**Subject: October 2013 Inspection Report
Cameco Resources Permit 603**

OCTOBER 2013 INSPECTION REPORT

PERMIT 603

Figure 2 New piping for underground haulageway restoration wells CIMW-1 and CRMW-3

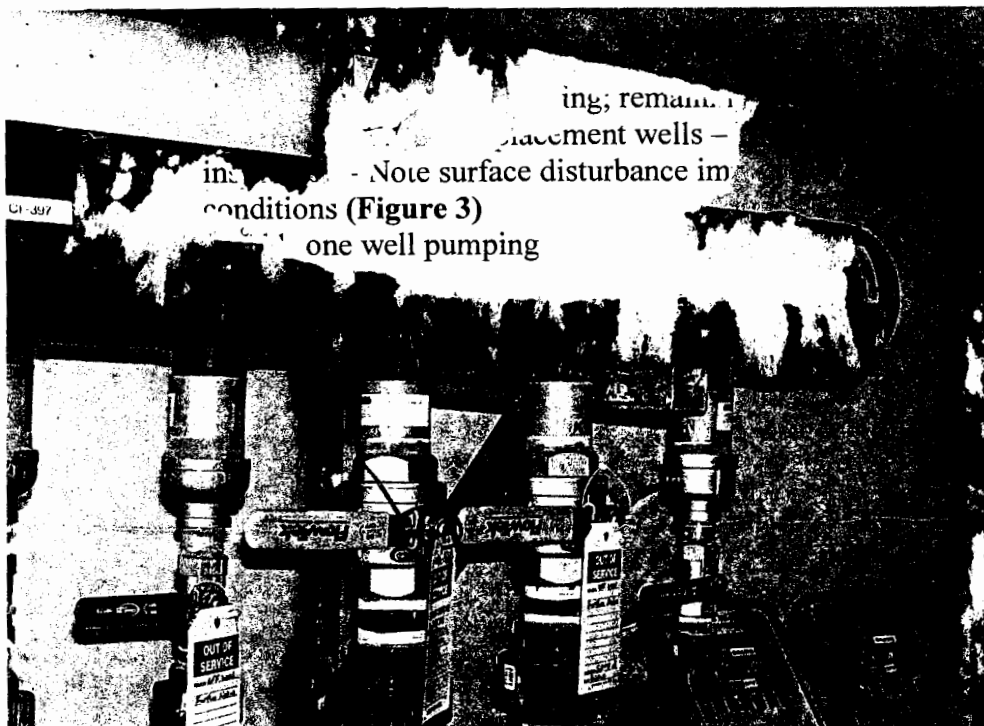
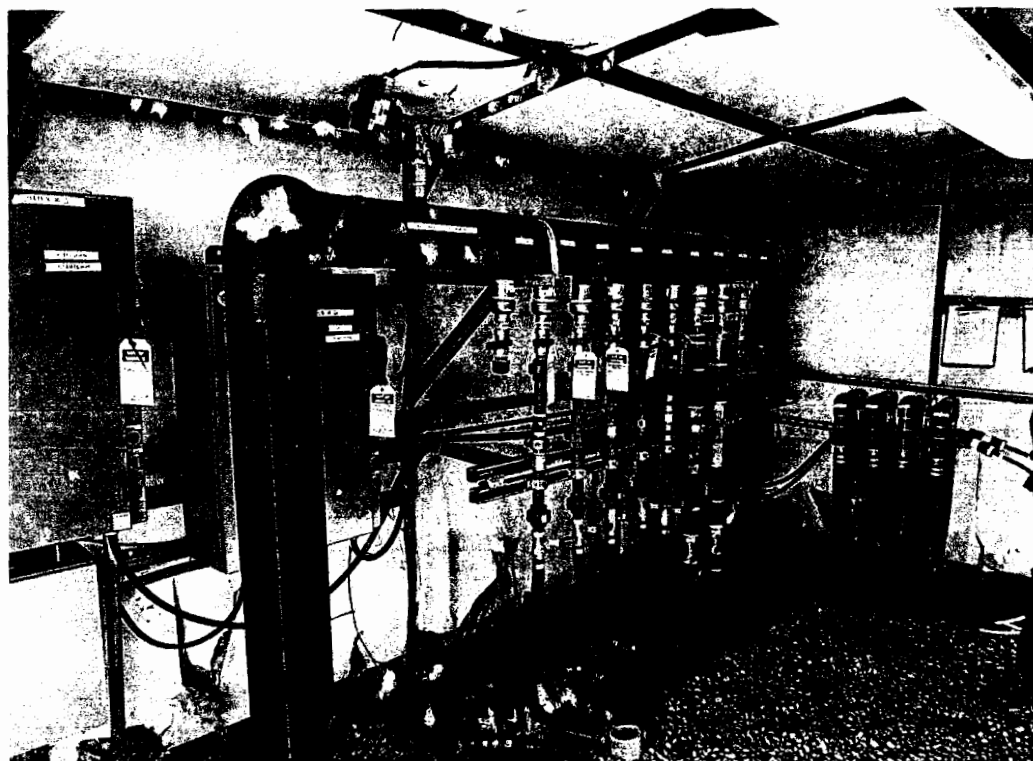
- Inspected HH 12, GWS
 - Inspected HH E12 also used for HHD2-3, DP-22 operating
- MU-C
 - Six wells along the haulageway @ approx. 600' piped to HH C-19 (**Figures 2, 3 & 4**) Request to turn on the wells but need approval for converting the wells (will discuss at meeting with LQD Supervisor on 10-25-14)

1. The wells used for the underground haulageway restoration (CIMW-1, CRMW-2, CRMW-3 and CRMW-4) were noted to be piped into HH -C19 during the inspection. To date, Cameco does not have an approved restoration plan for the haulageway. LQD sent review comments addressing the proposed plan on January 3, 2013. No response has been received. LQD agreed to allow Cameco to pursue restoration of some mine units while restoration plans and reviews are in progress. However, delays in the reviews to approve the restoration plans are not acceptable. Please submit the responses to comments within 30 days.
